Document: "FTMM-12 Landfill and Demolition of Building 909, Fort Monmouth, New Jersey"

SUBJECT: FTMM-12 Landfill and Demolition of Building 909
Fort Monmouth, Oceanport, Monmouth County
PI G000000032

**FTMM-12 LANDFILL BOUNDARY REFINEMENT
AND METHANE GAS SURVEY RESULTS**

FIGURE F1

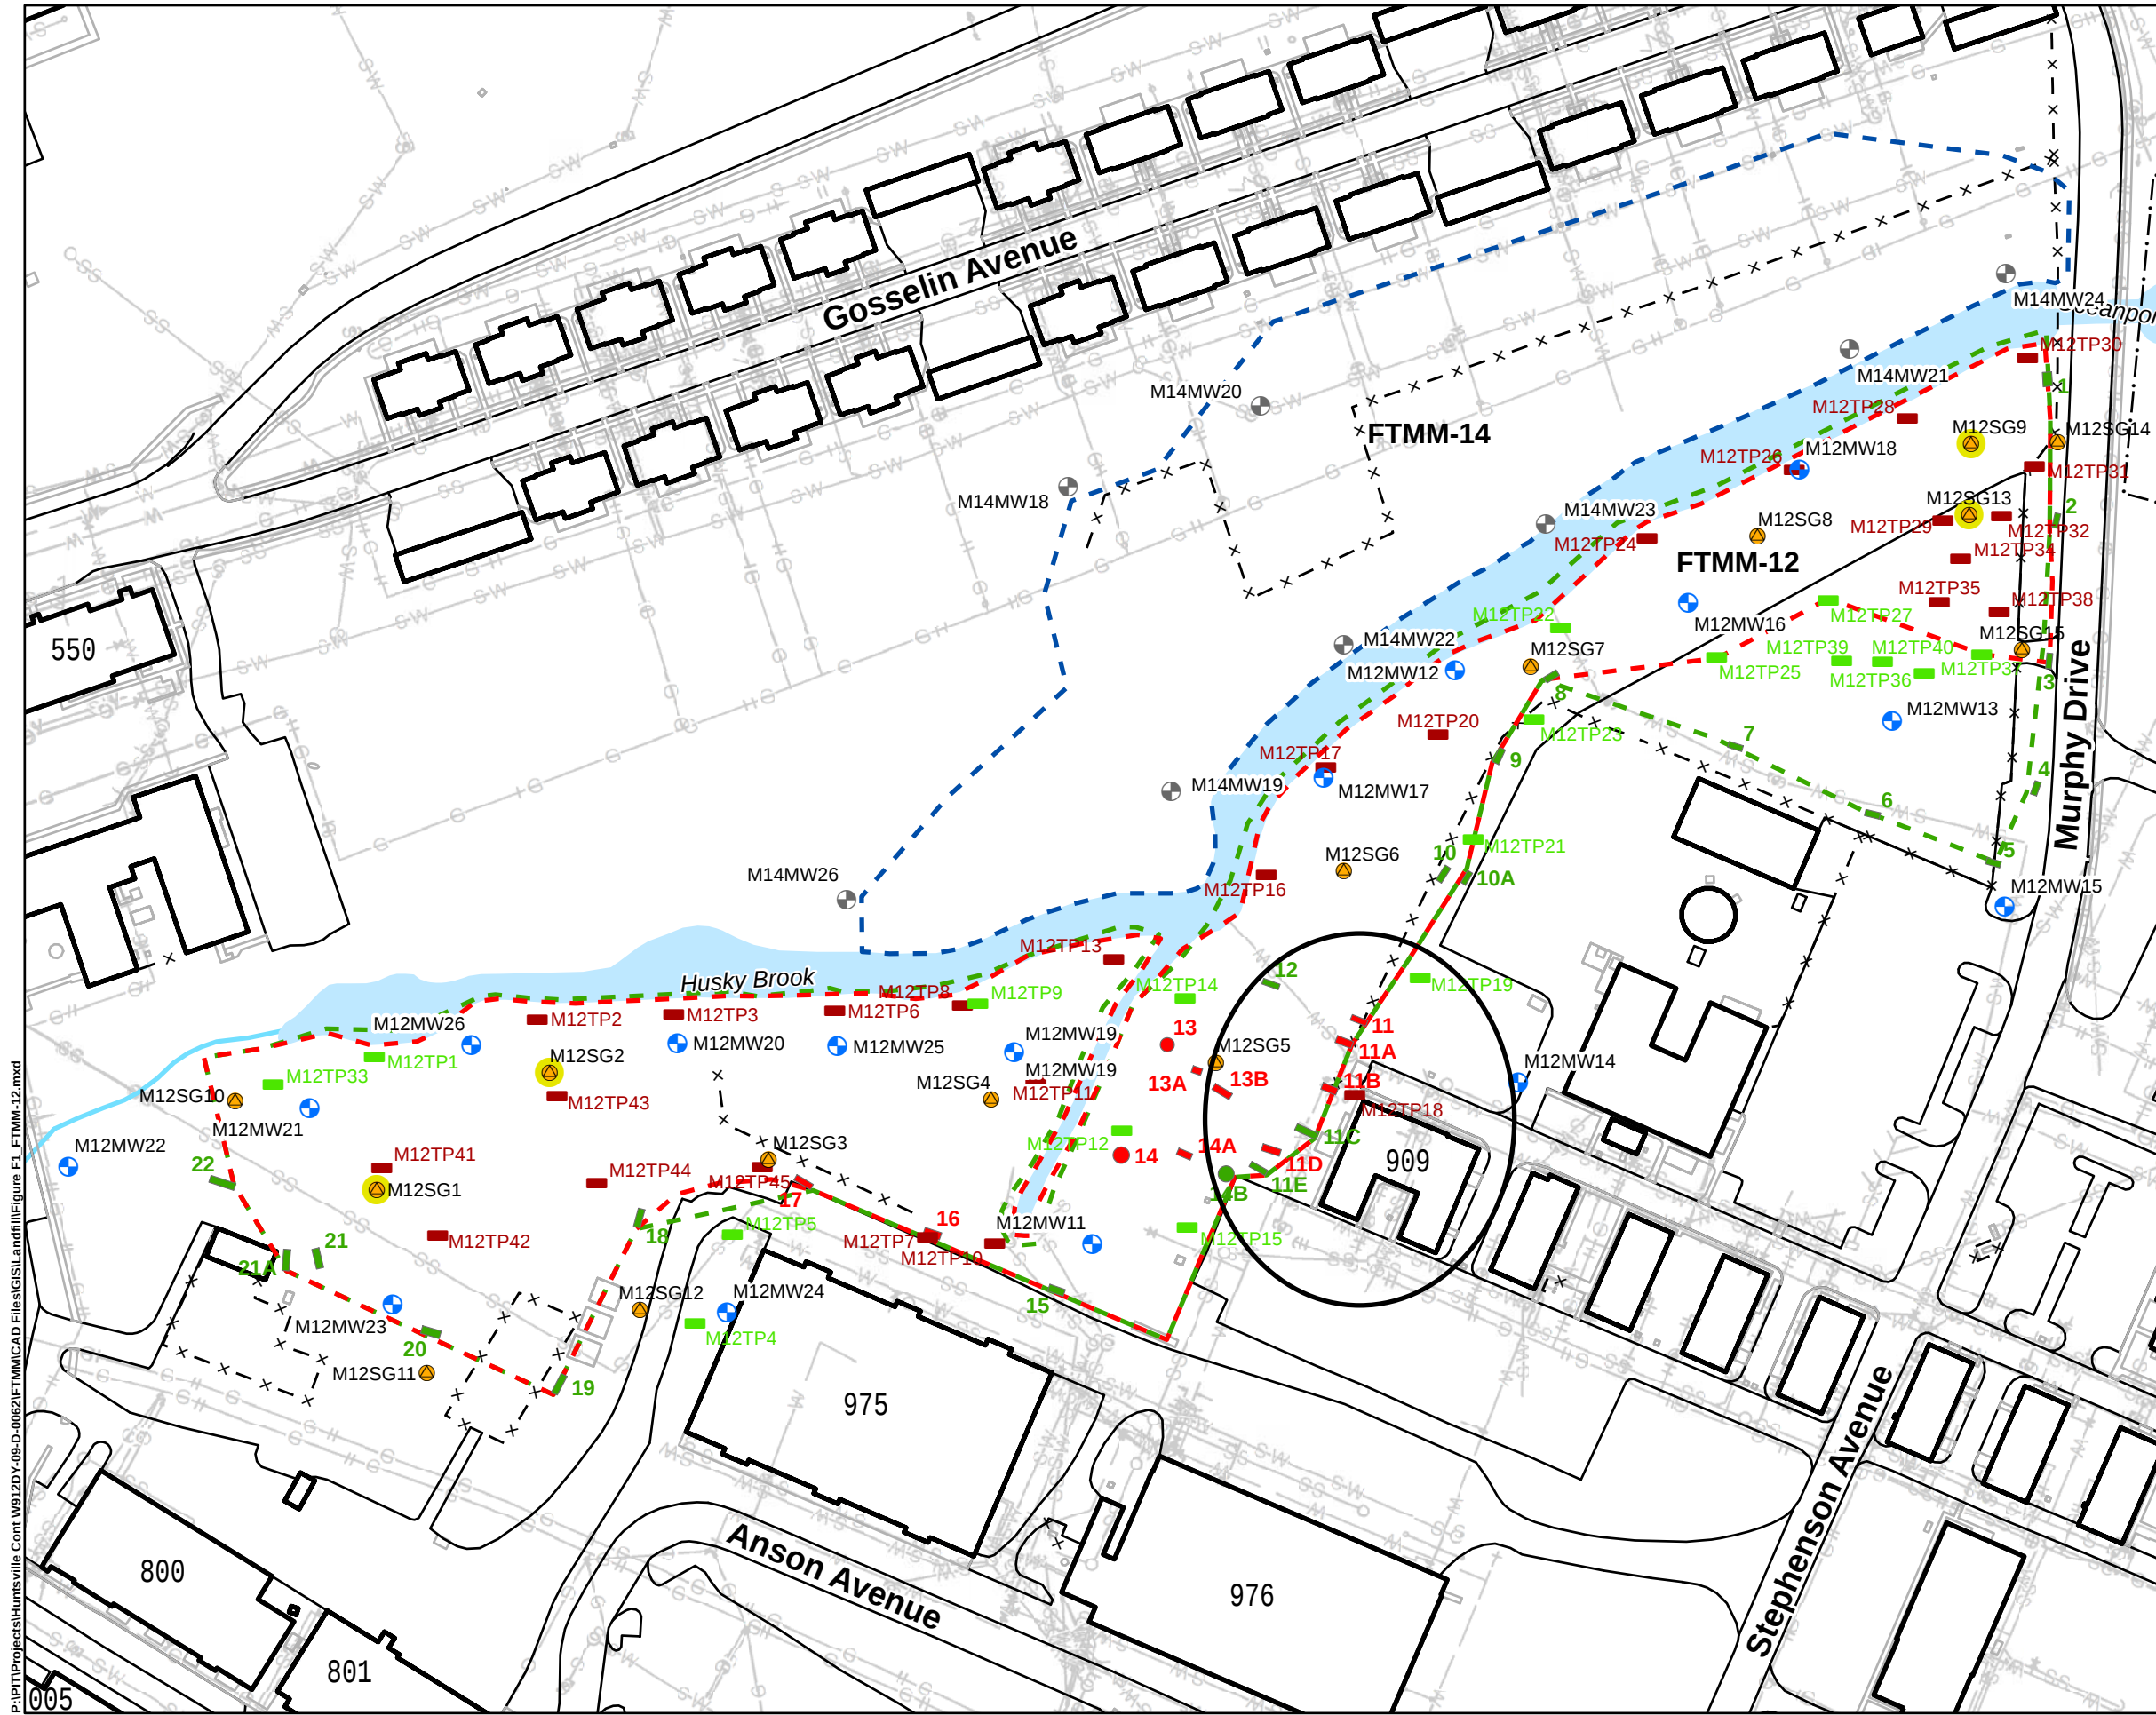
Waste was observed in test pits TP11B, TP11C, and M12TP18 located along the southeastern perimeter of the FTMM-12 landfill, adjacent to Building 909. The location of the test pits in relation to Building 909 are shown on the attached Figure-F1. As agreed by the NJDEP during the 12 April 2017 meeting, the typical approach for addressing observed waste in test pits located outside the landfill boundaries is to either excavate the waste from the areas where it was observed and consolidate it under the associated FTMM landfill cover or extend the cover over to the observed waste area.

USACE proposed Building 909 to be demolished since removal of the building would facilitate the execution of the remedy in a small area adjacent to the building where excavation of material could potentially undermine the structure and impede complete removal of waste. The demolition debris was proposed to be disposed into the FTMM-12 landfill and regraded with the existing landfilled material since the landfill contains similar waste types. The Building 909 demolition debris will be disposed within the boundaries of the landfill. The Building 909 demolition debris would be regraded along with the existing material contained within the landfill bounds to form the subbase after which the two-foot vegetated soil cover will be installed.

The NJDEP was not in agreement with adding Building 909 demolition waste in the FTMM 12 landfill, accordingly the USACE will not demolish Building 909. Excavation of waste starting in TP11B and TP11C will occur and proceed outward from the landfill limits until no longer encountered (see criterion discussed below) or will terminate if it is determined to impact the structural integrity of Building 909 or the adjoining walkway is compromised. Waste removed from the excavated areas will be placed within the landfill boundary and graded along with the other landfilled material to serve as the subbase for the landfill cover. After regrading is completed the final two-foot cover will be installed.

As requested by the NJDEP during the 12 April 2017 meeting, the Army established a criterion for the construction of the landfill covers to determine if wastes encountered outside the landfill limits would require either excavation and relocation under the landfill cover or would be left in place with the extension of the soil cover over the location of the waste (US Army, May 2017). The requested criterion, as outlined in the "Landfill Boundary Refinement and Methane Gas Survey Report for the Nine Landfills" (Parsons January 2016), is as follows:

- Contiguous soil and waste/debris mixture (action required).
- Soils with miscellaneous singular pieces of debris or scattered debris that is not contiguous. Debris of *de minimus* quantity; (no action).
- Soils only. No waste/debris observed; (no action)
